Summary of Items Discussed in 1/2013 APSEC Discussion Forum on 4 January 2013

SCHEMATIC SECTION

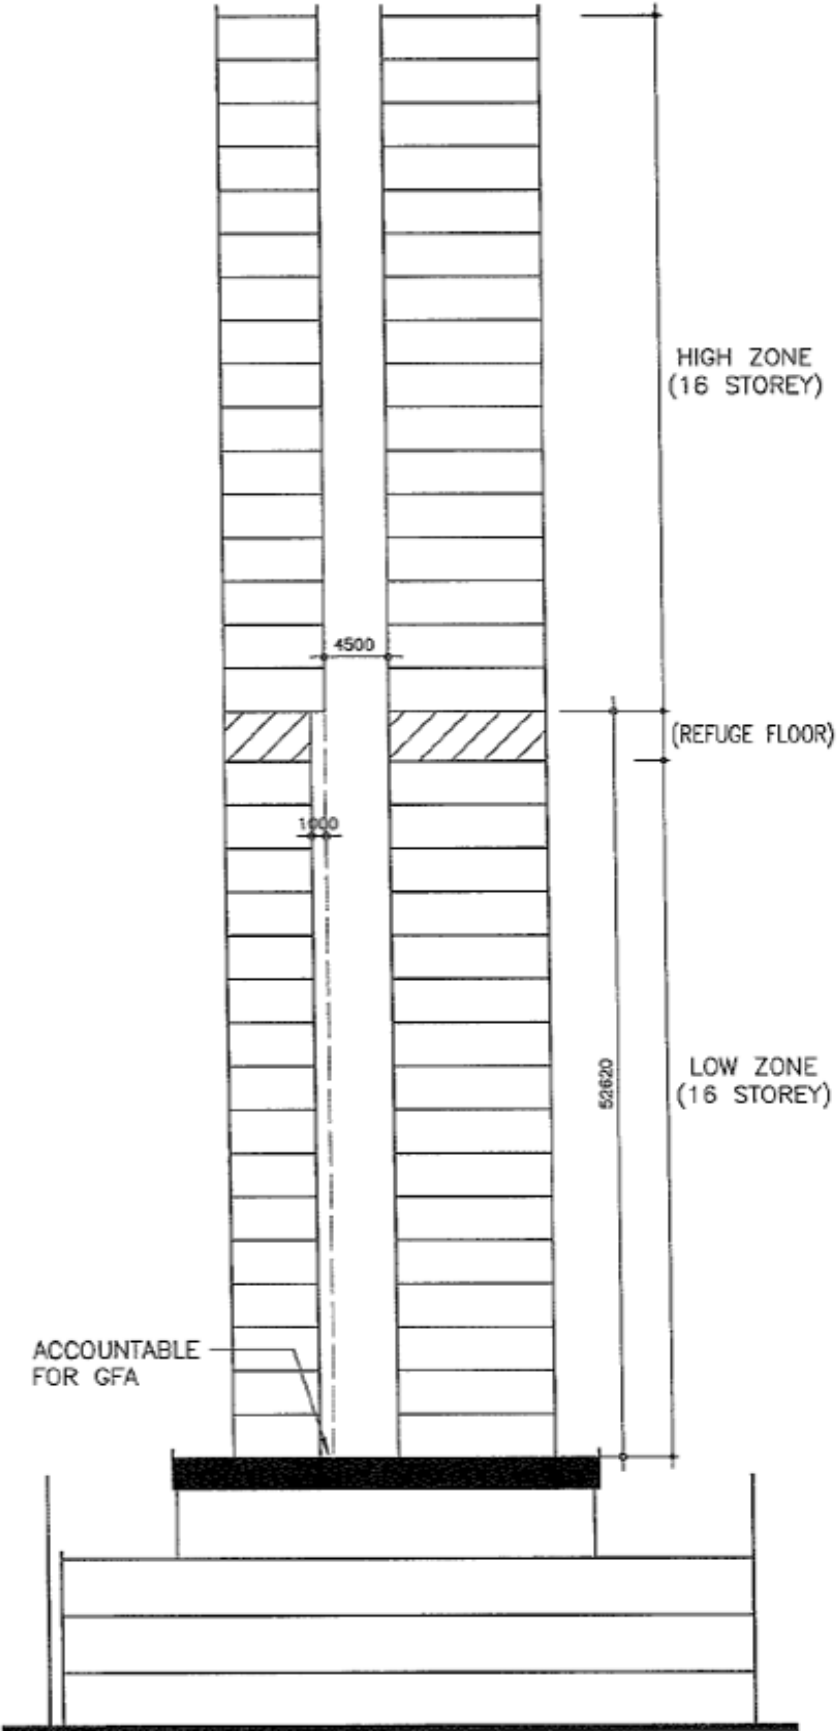
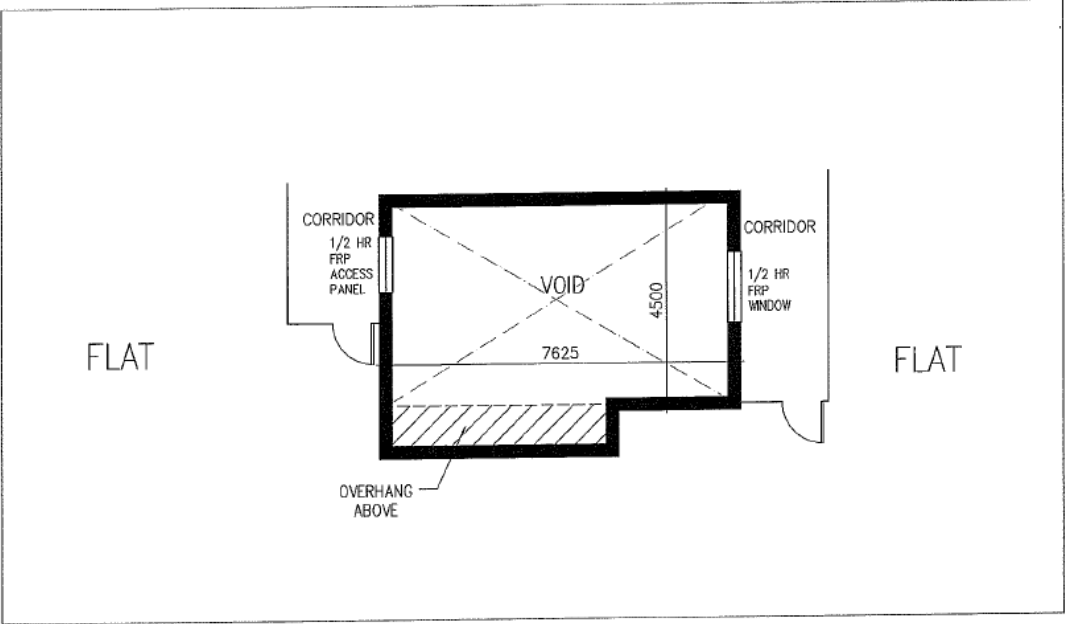
10.	<p><u>GFA calculation of air space beneath overhang floors</u></p> <p>As per attached drawing (Appendix I), the special units on the top few floors of a residential tower is different from the typical floors below resulting in a slight overhang way above the transfer plate at the lowest floor situated within an internal void of some 4.5 m by 7.5 m. At the overhang location, the air space is all enclosed by wall, sometimes structural wall and the space is visible from common area, i.e. common corridor or common staircase. Not to mention that all the owners in the building is governed by DMC forbidding them to make any alteration to the external wall, it would be extremely difficult for the owners to attempt any unauthorized building works under the circumstances mentioned above. Also, the area underneath the overhang space on the lowest floor has already been accounted for GFA calculation. The question is whether the air space between the lowest floor and the overhang floor is accountable for GFA calculation on a floor by floor basis. We would like to point out the we have been advised in previous occasions that if it is not a modification case, BD normally would not use the suspected possible UBW as ground for disapproval. In this case, the chance of UBW is practically nil.</p>	<p>The BD responded that whether the air space beneath an overhang had to be accountable for GFA calculation should be considered case by case. In general, overhang on the exterior would be more likely to be accepted than overhang in internal voids / lightwells as there was a possibility that internal voids tend to enlarge the bulk of the building.</p>
